**APPLICATIONS BY LONDON ASHFORD AIRPORT LTD**

**SITE AT LONDON ASHFORD AIRPORT LIMITED, LYDD, ROMNEY  
MARSH, TN29 9QL**

**REBUTTAL AND SUPPLEMENTARY  
PROOF OF EVIDENCE OF  
MALCOLM SPAVEN MA (Hons) MSc**

**AVIATION OPERATIONAL ISSUES**

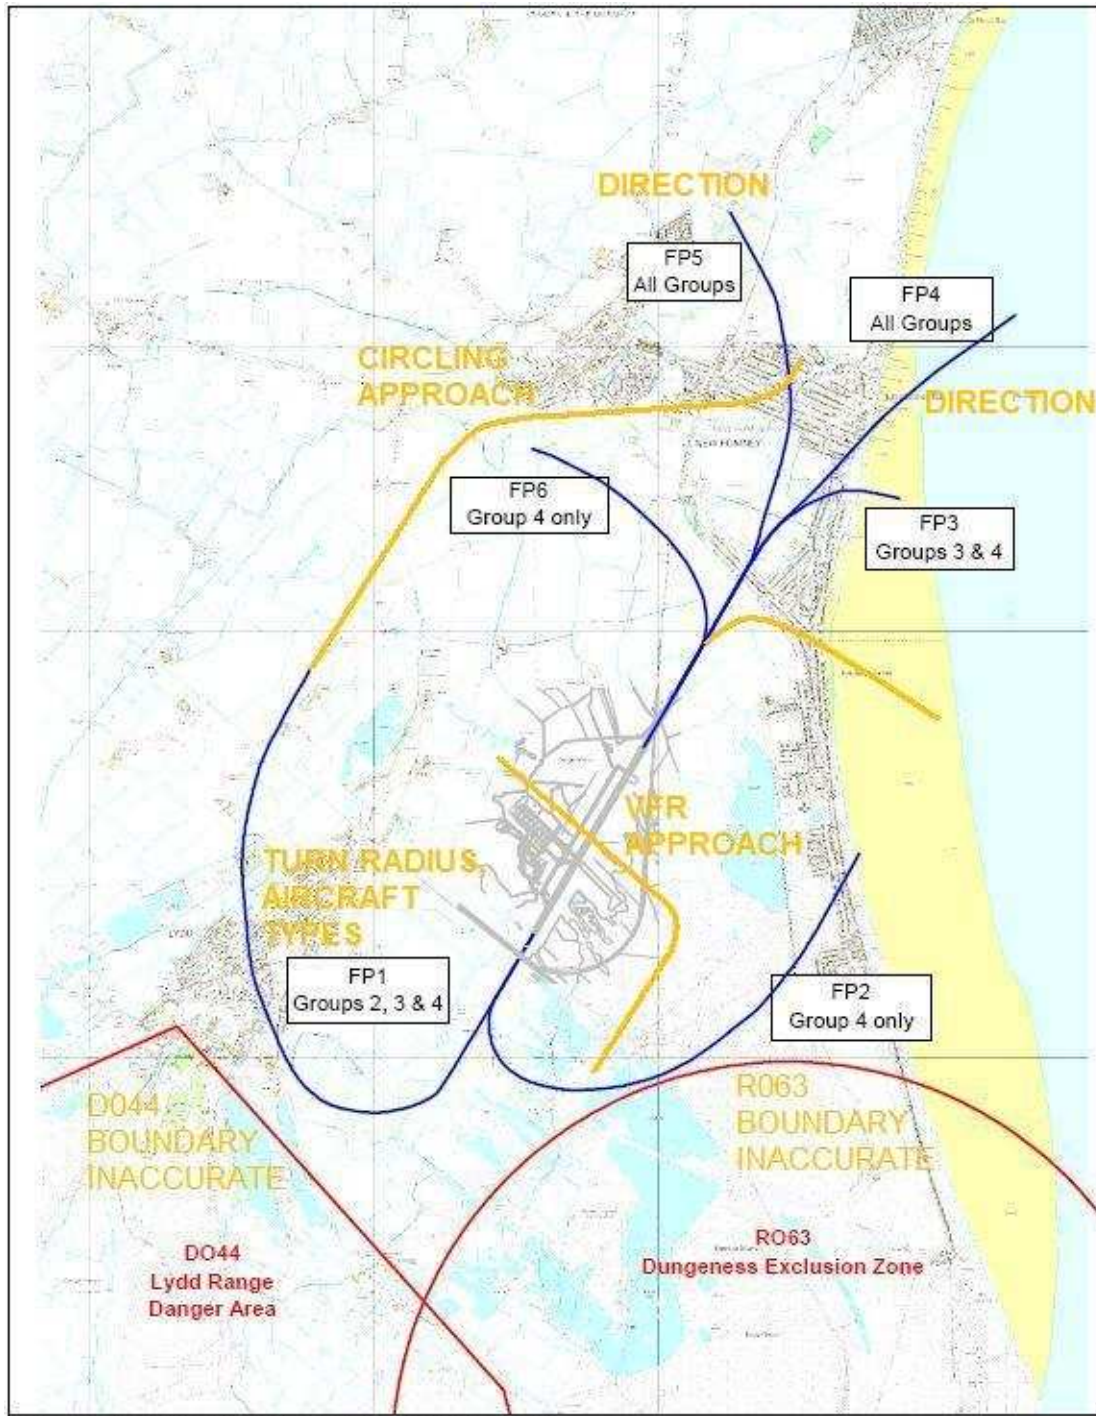
7.15 In addition, the ESR report was written prior to the introduction of the RNAV approaches at Lydd in 2009. At the top of p.5 the report discusses the issue of the offset ILS approach to runway 21. It states:

*any change in future operations is most unlikely to increase the angle of offset of the approach and that, if any change in approach procedures were to occur, this would be more likely to reduce and perhaps eliminate the offset.*

However, the RNAV procedures for runway 21 are, contrary to the above, offset by a further 9° to the west of the offset ILS approach. An aircraft experiencing a problem in the late stages of this approach and being unable to execute the required right turn missed approach – a scenario acknowledged on pp.27 and 31 of the document – would pass some 1.7 to 1.9 km (depending on aircraft category) to the west of the power stations (defined as the centre of the restricted airspace R503). This compares with a 'miss distance' of some 3.0 km for a similar scenario involving an aircraft flying the ILS approach to runway 21. Thus the report's conclusions on the risk presented by the fact that the instrument approach to runway 21 is offset by 5° are unreliable.

Annotated version of LAA/5/C Figure NV01

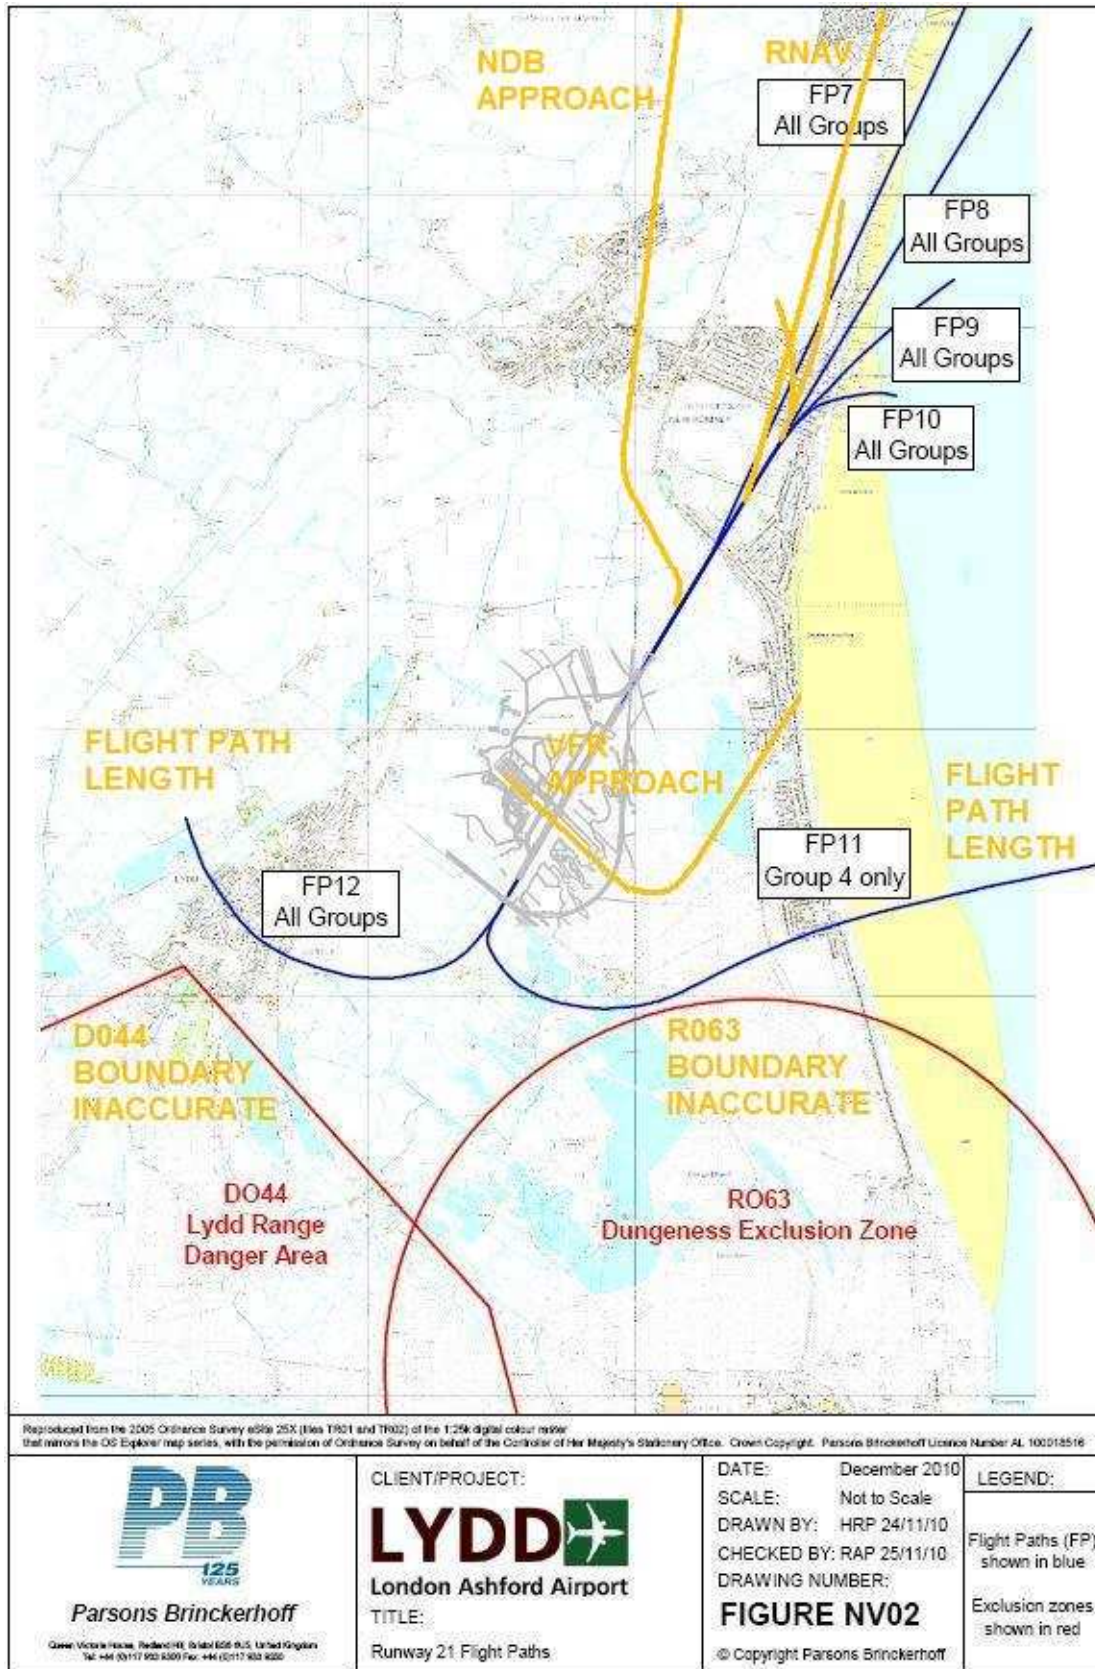
4.5 There are additional difficulties with the depicted orientation of some of the flight paths. For example, FP4 on Figure NV01 is consistent with a departure direct to the Dover VOR, which is one of the recommended standard routes for airways traffic departing from Lydd. However, as shown on Figure NV01, FP4 would take aircraft through the Hythe Range D141. When this range is active, aircraft following FP4 would have to be certain of being capable of climbing above 3200 feet before reaching the boundary of the danger area. However, with most airliner types it is unlikely that the crew could guarantee being comfortably above 3200ft before reaching the danger area boundary. Therefore they would not follow FP4.

4.6 Similarly, FP5 is not consistent with a departure to the Detling VOR, which is the recommended departure route to the north-west. This would require a turn further to the north west. There is also no flight path depicted on Figure NV01 for aircraft departing to the south west from runway 03.

4.16 It should also be noted that, while Figures NV01 and NV02 - in common with their predecessors, Figures 16.1 and 16.2 of CDs 1.41a and 1.41b - are labelled 'Not to Scale', it would not be unreasonable to expect that they portray the locations of relevant aviation features with a reasonable degree of accuracy. However, as stated in my submission on behalf of LAAG to Shepway District Council on 7 April 2009, in response to the airport's March 2009 SEI, and repeated in paragraph 3.35 of my main proof [LAAG/10/A], the

4.17 This is now the sixth time since April 2007 that LAAG has pointed out, in publicly-available submissions, inaccuracies in the depiction of the D044 and R063 boundaries. If the determination of the two planning applications before the inquiry is to be based on accurate data on the flight paths, then the airport needs to correct the depicted restricted airspace boundaries and provide evidence that it has conducted a re-assessment of the flight path assumptions – including dispersion tracks – following those corrections.
